Access Compliance Report

Public Rights-of-Way

(Curb Ramps)

Intersection ID: 8938	Main Street: NORRIS_AV	Cross Street: NEWLAND_RD	Location: NE
ADA ID: 0EF5733D3E0B	Ramp Type: Perp	Initial Pass/Fail: Fail	Overall Compliance: No
			Severity Score: 21.25

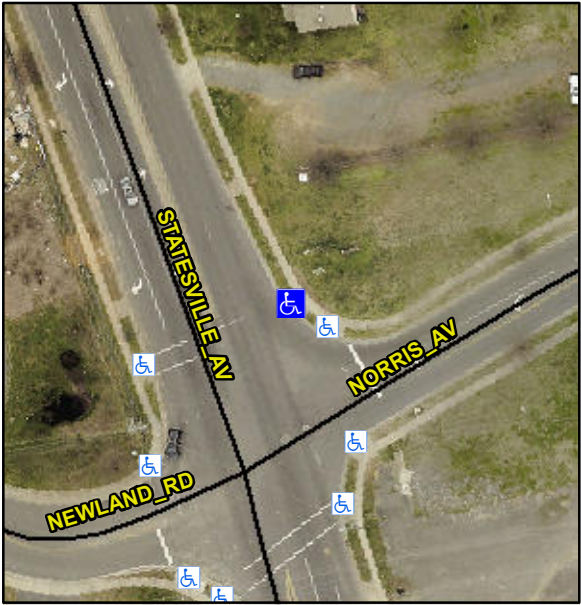
Codes/Mitigation Info/Possible Solution			Field Measurements/Component Compliance		
	Possible Solutions:		Compliance	Description	Data
	Remove & Replace Entire Ramp.		N/A	Ramp Length (in)	59.0
			No	Ramp Width (in)	41.0
			N/A	Flare Type LT	N/A
			N/A	Flare Slope LT (%)	N/A
			N/A	Flare Traversable LT?	N/A
			N/A	Landing Length (in)	N/A
			N/A	Landing Width (in)	N/A
			N/A	Landing Slope (%)	N/A
			N/A	Landing X Slope (%)	N/A
<p>Surveyor Notes:</p> <p>N/A</p> <p>PROW/ADA:</p> <p>Not Found, R304.5.1, R304.2.2</p>			N/A	Flare Type RT	N/A
			N/A	Flare Slope RT (%)	N/A
			N/A	Flare Traversable RT?	N/A
			N/A	DWS Provided?	N/A
			N/A	DWS Contrast?	N/A
			N/A	DWS Length (in)	N/A
			N/A	DWS Full Width?	N/A
			N/A	DWS Offset (in)	N/A
			N/A	Gutter Ponding?	N/A
			N/A	Gutter Lip Ht (in)	N/A
<p>Total Cost:</p> <p>\$ 1850.00</p>			No	Painted X Walk1?	N/A
				X Walk 1 Direction	To SW
			N/A	X Walk 1 Width (in)	N/A
				X Walk 1 Slope (%)	2.7

X Walk 1 X Slope (%)	0.5
			N/A	Ramp inside XWalk1?	N/A
			N/A	Road Slope (%)	N/A
			N/A	Road X Slope (%)	N/A
			N/A	Any Obstructions?	N/A
				Obstruction Type	
			N/A	Clear Space?	N/A
			N/A	Clear Space to XWalk (in)	N/A
			N/A	Storm Grate/Utility Hazard?	N/A
				Storm Grate/Utility Type	
			N/A		N/A
			Yes	Surface Condition? (G/P)	Good
